Errata for the Compute Express Link Specification Revision 3.2

March 17, 2025

Errata for the Compute Express Link Specification Revision 3.2

IMPLEMENTATION NOTE

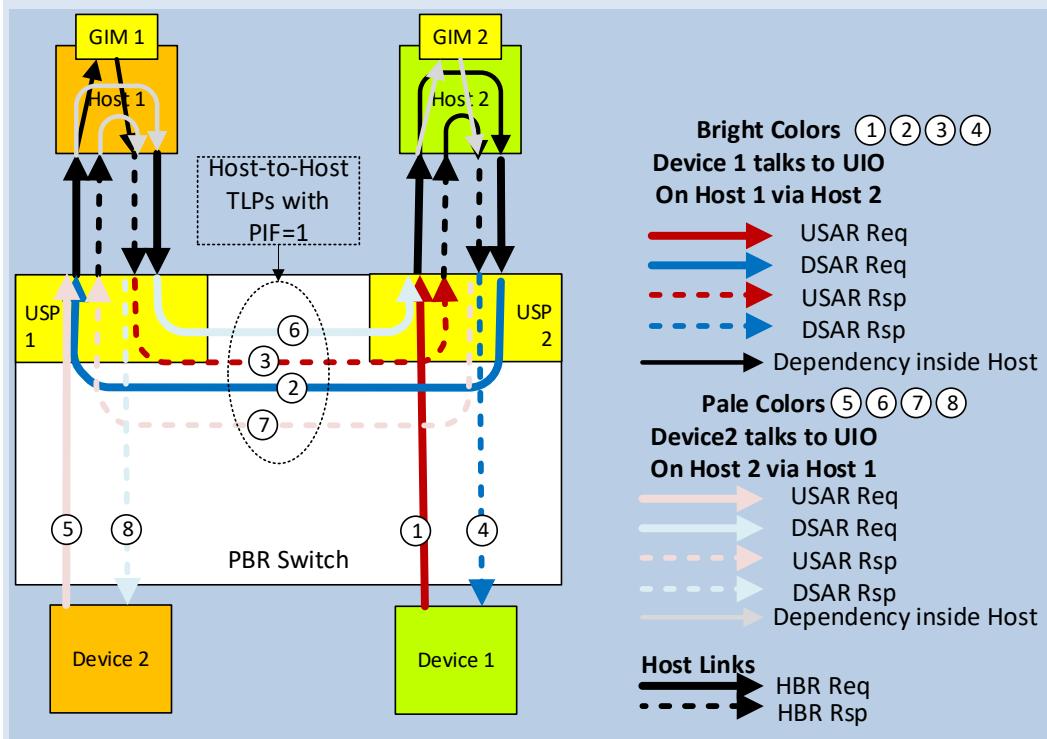
This section has major problems with its characterization of the deadlock issues and its suggested avoidance approaches. This erratum corrects the characterization of the deadlock issues and offers alternative workarounds.

Host-to-Host H2H UIO usages can result in deadlock ~~when mixed with UIO traffic going to the host that can route back in the host, if a host introduces shared resources between the following two roles. Refer to the Implementation Note below to see an example deadlock.~~

[Here is an example deadlock with GIM, based on circular request dependencies that arise when devices under multiple GIM hosts are accessing remote GIM concurrently.](#) In this example, circles 1-4 represent UIO TLPs in the path when device 1 accesses GIM 1 on host 1. Circles 5-8 represent UIO TLPs in the path when device 2 accesses GIM 2 on host 2.

[In this example, UIO Request \(Req\) dependencies form a closed loop of head-of-line \(HOL\) blocking instances, specifically:](#)

- At USP 1 egress, USAR Req 5 blocks DSAR Req 2 due to HOL blocking
- At host 2 egress, DSAR Req 2 blocks USAR Req 1 due to HOL blocking
- At USP 2 egress, USAR Req 1 blocks DSAR Req 6 due to HOL blocking
- At host 1 egress, DSAR Req 6 blocks USAR Req 5 due to HOL blocking
- This completes the circle, resulting in deadlock

[In each HOL blocking case, the fundamental cause is comingling USAR & DSAR Requests in the same flow control class traversing an HBR link.](#)

- H2H responder role: The host is an H2H UIO responder.
- UIO forwarding role: The host performs any operation where a given UIO TLP is ingressed at an RP and later egressed at the same RP or another RP. This includes forwarding H2H or non-H2H TLPs, as well as reflecting TLPs sent to the RC for validation and/or remapping, e.g., by ACS P2P Redirect mechanisms.

There are different approaches to avoid such deadlocks. For example, with a host that plays a H2H responder role, ensure that the host never plays a UIO forwarding role. More specifically, ensure that no devices send UIO TLPs that require forwarding or reflecting by their local host. Note that:
